City of Bowie, Maryland
Allen Pond Park Stage and Stage Canopy Renovation
Invitation for Bids (IFB)

Addendum #1

Date: October 2, 2025

E402

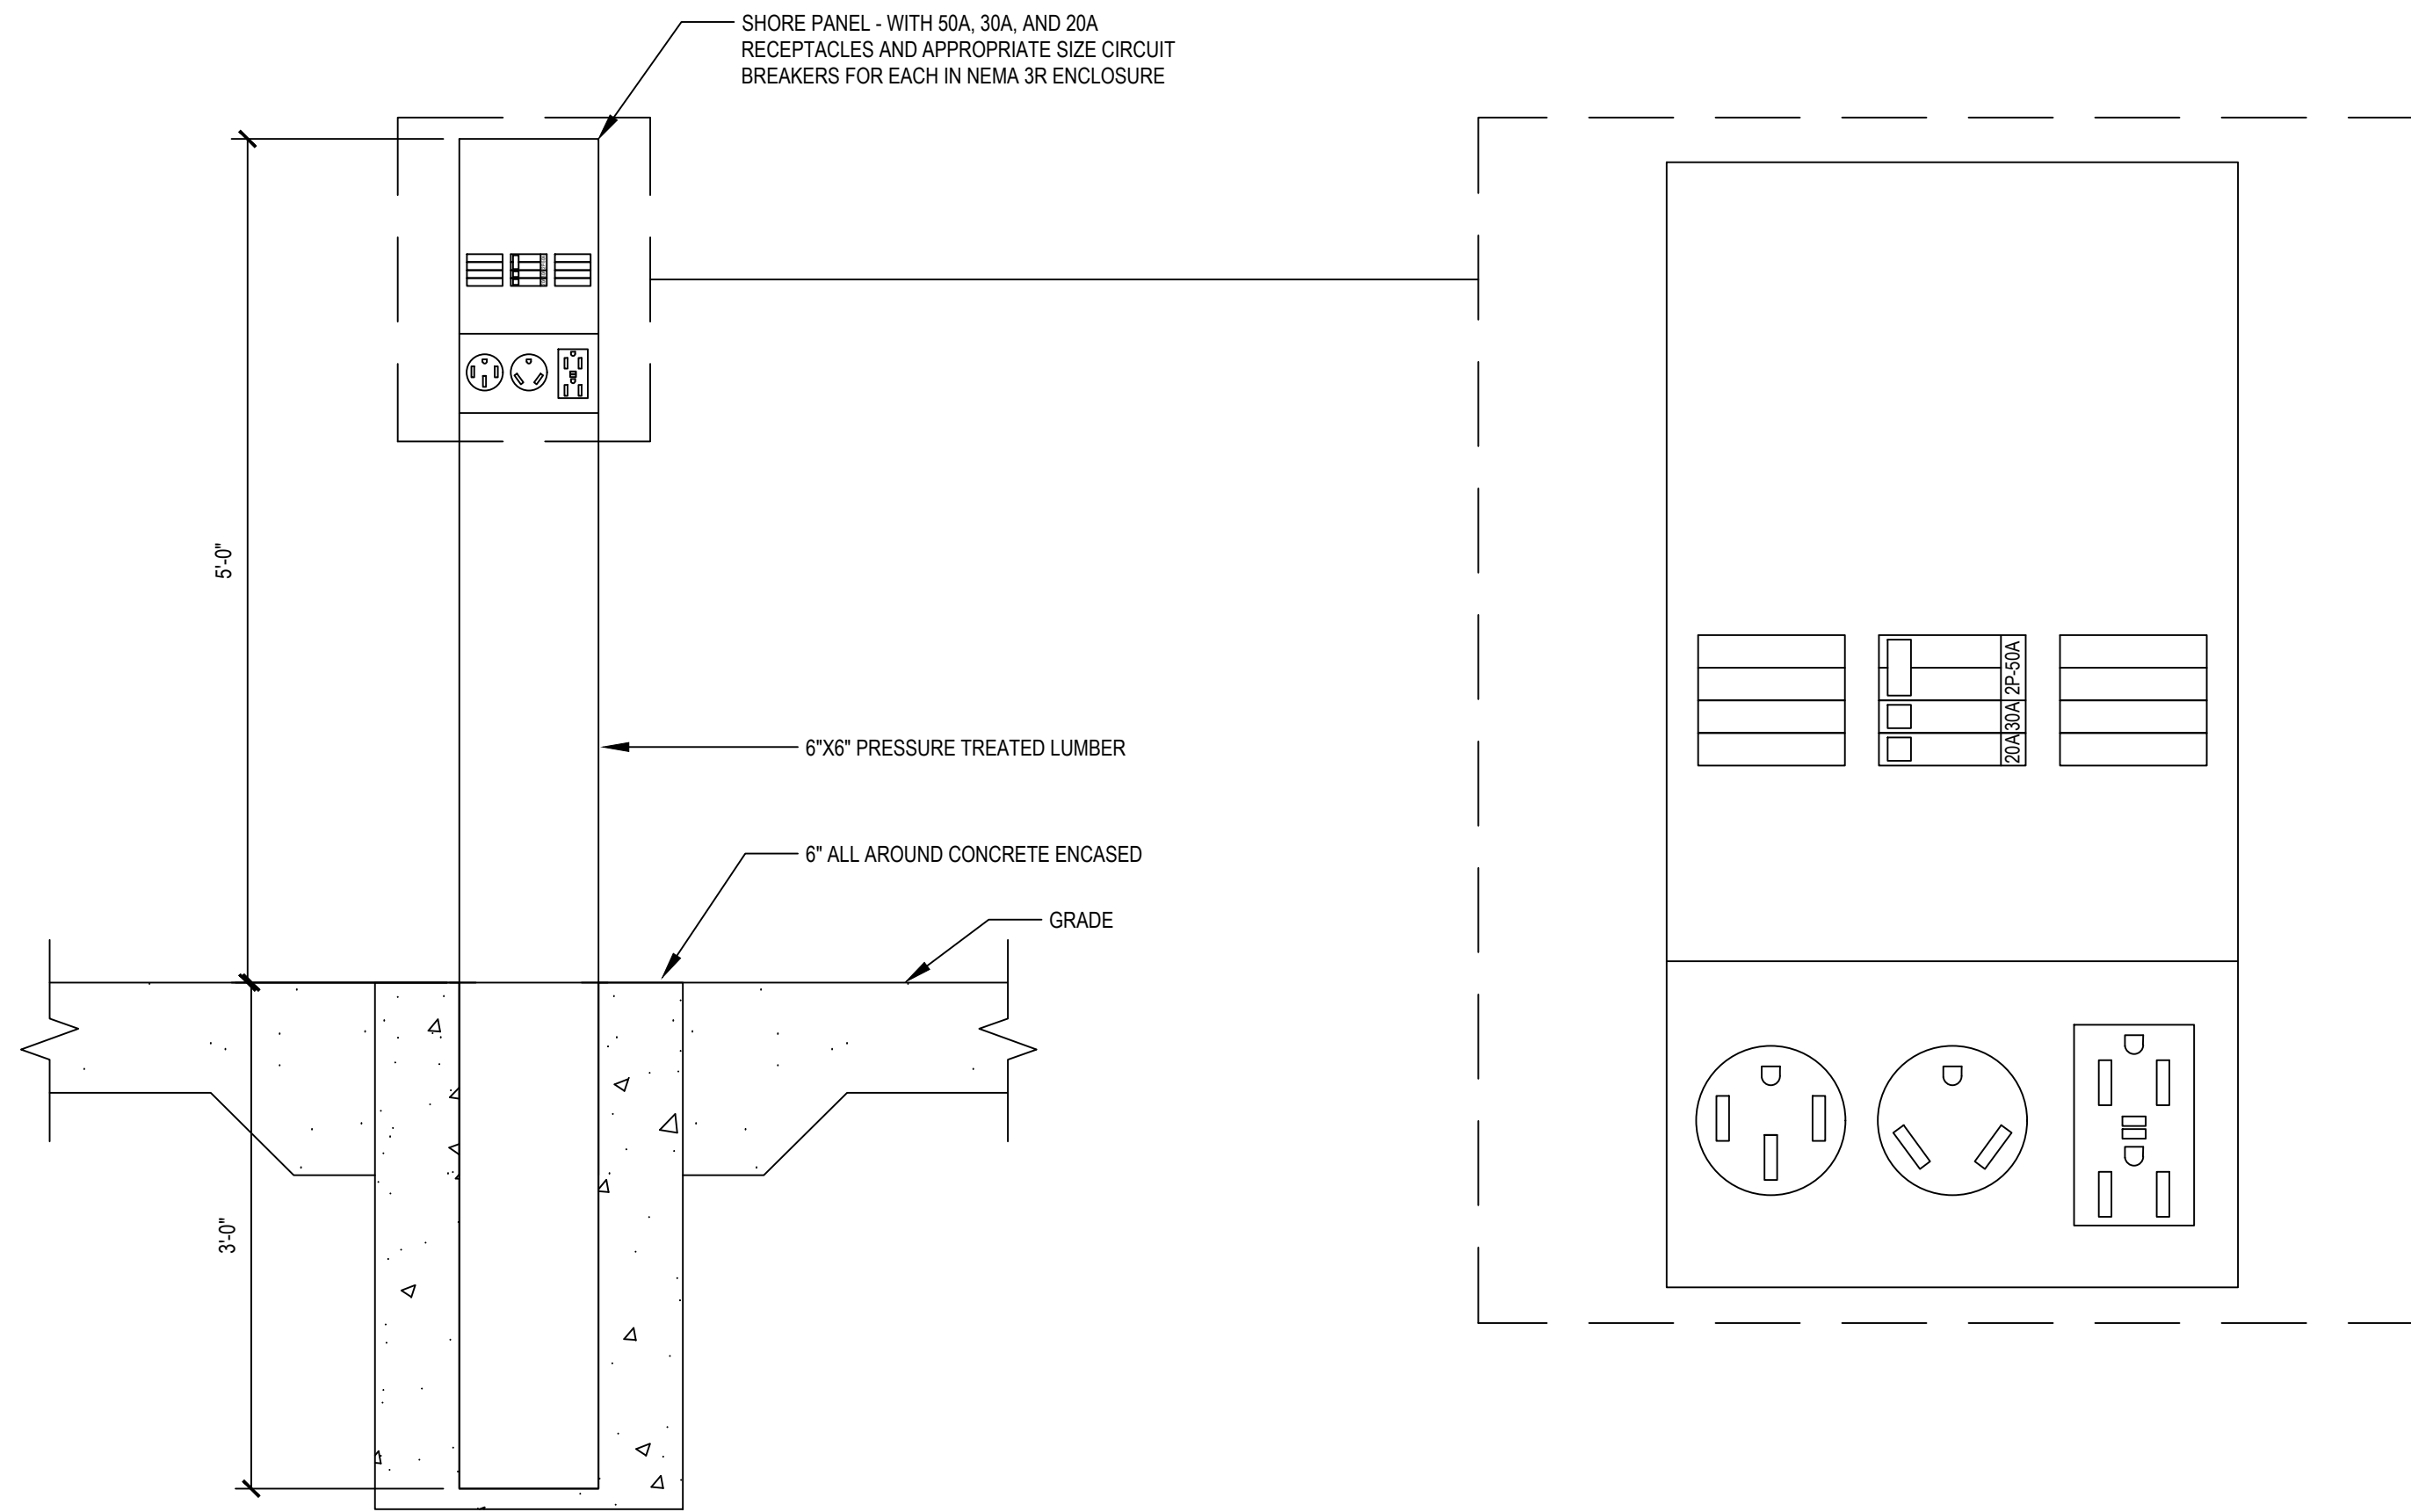
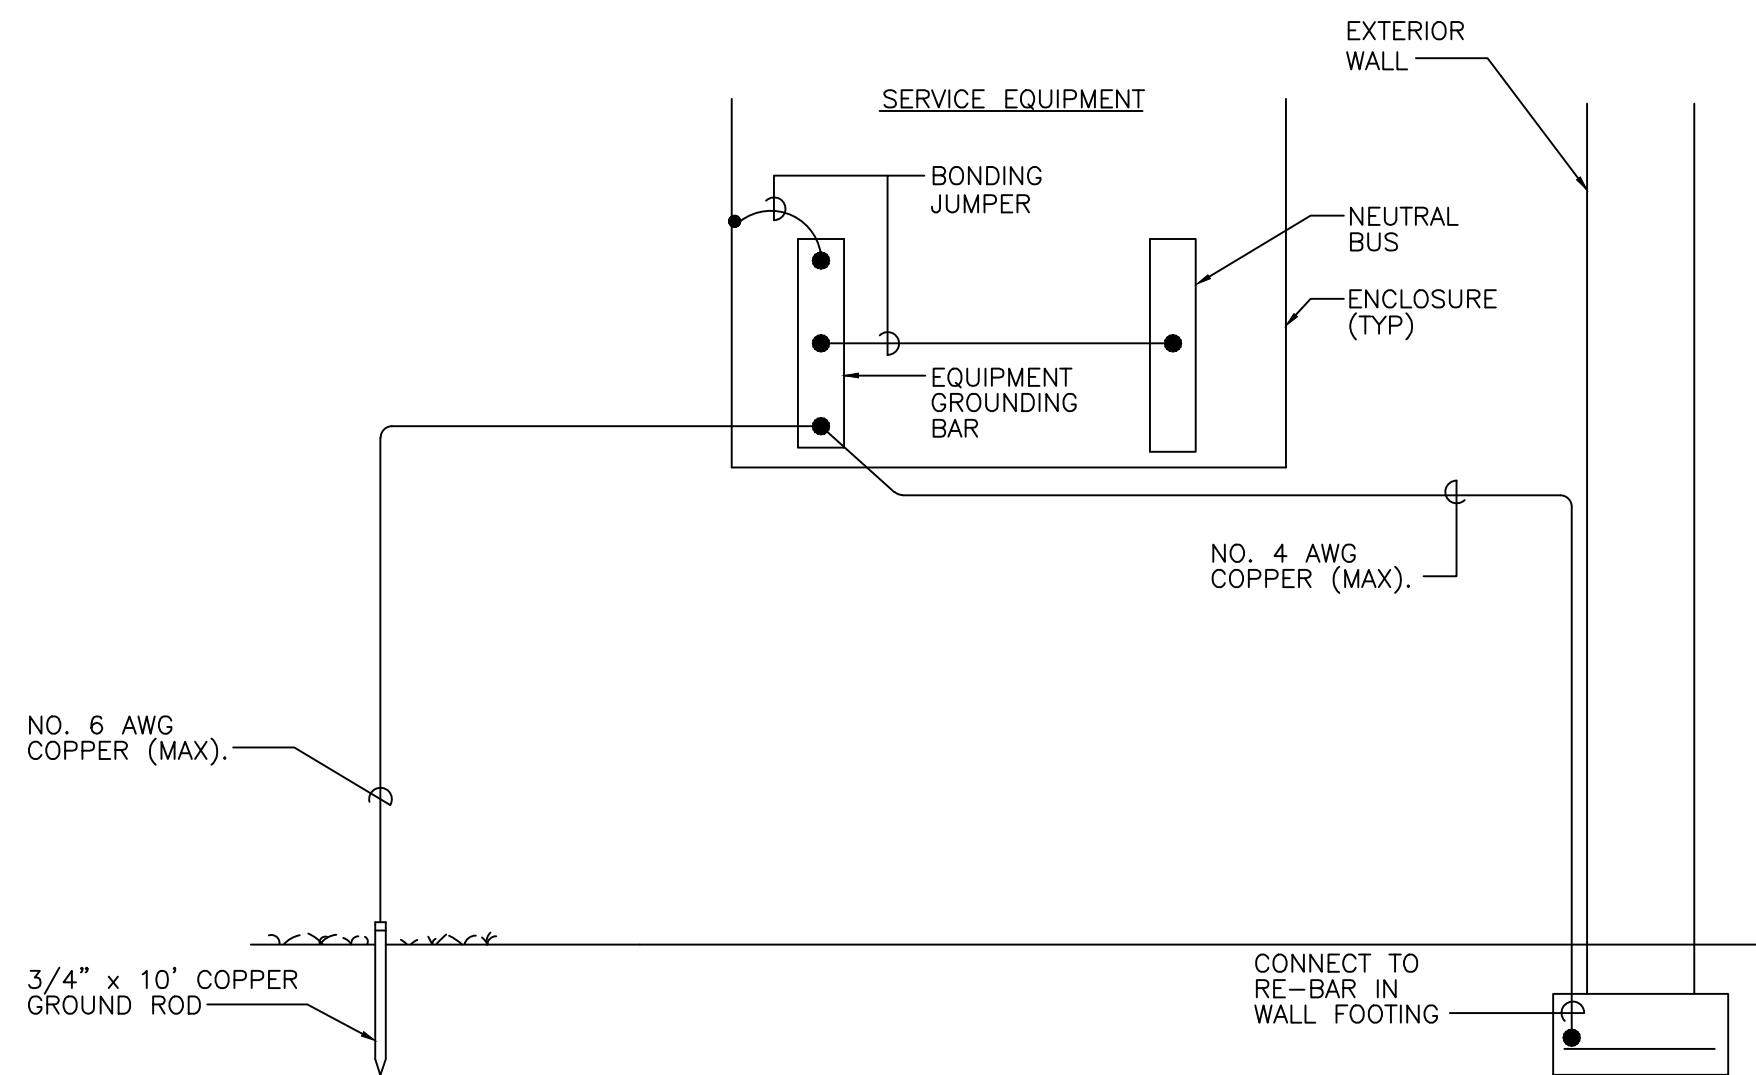
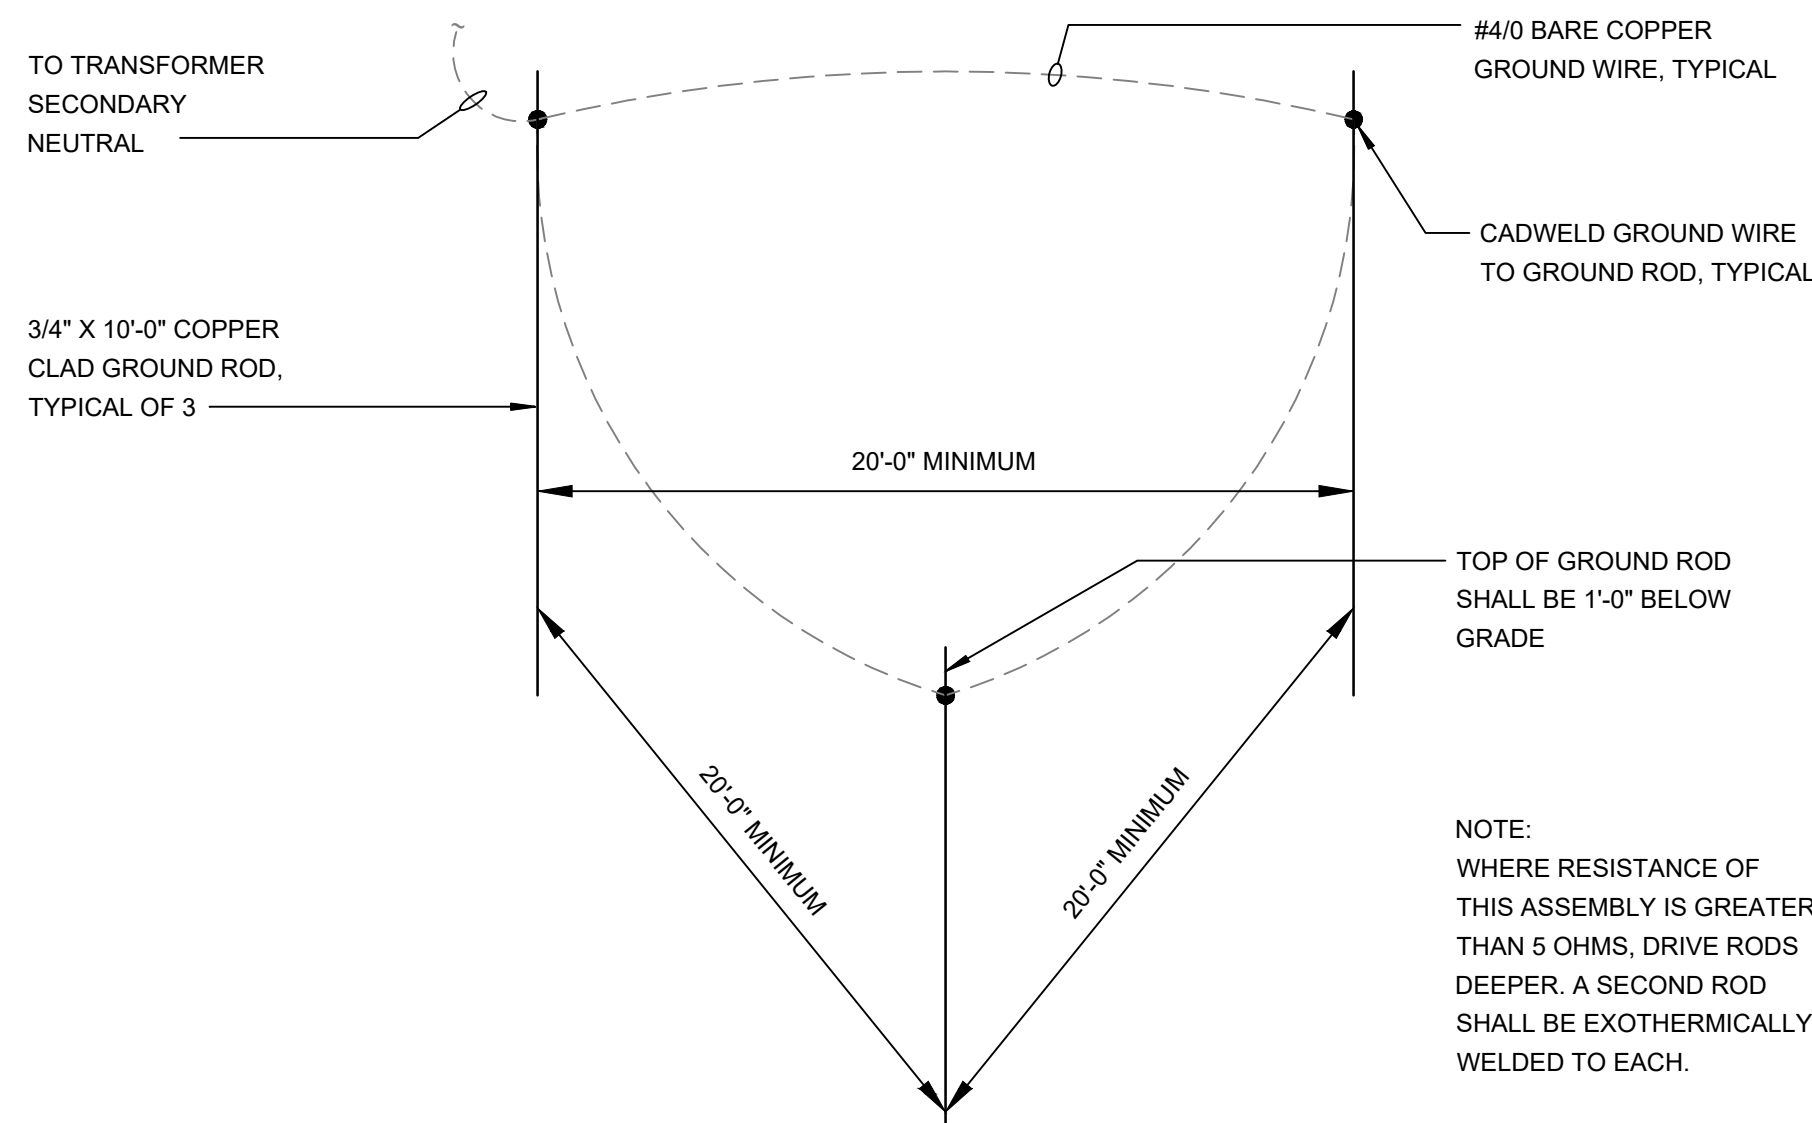
- E401** Modified Detail 2/E401 to remove “IT Cabinet.”
- E402** Added Detail 2/E402, Shore Panel Enclosure; Detail 3/E402, Grounding Electrode System; and 4/E402, Ground Grid.
- E601** Removed Voltage Drop Schedule and modified Panel Schedules.
